MANDATORY SERVICE BULLETIN

MSB D4-088

Type: DA 40 D

Inspection of Turbocharger Hose

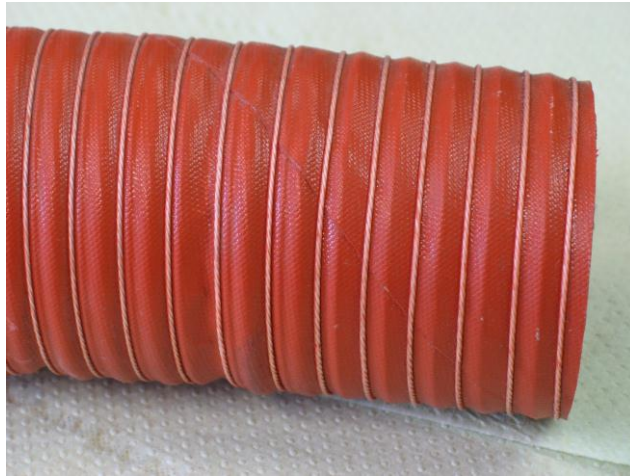
- **Suitable Quality:** 2 strings (one close to each side of the wire) and a maximum of bonding area between each winding

- Other Quality available (**NOT suitable**):

- Measures:
 - If a NOT suitable quality is identified, replace turbocharger hose with DAI P/N SG2M-64-920mm according to WI-MSB D4-075 Revision 1 or later issue.
- Action 2:
 - If clamp P/N D4D-7166-00-91 has not been installed yet (see picture above), carry out MSB D4-075/1 or later issue.
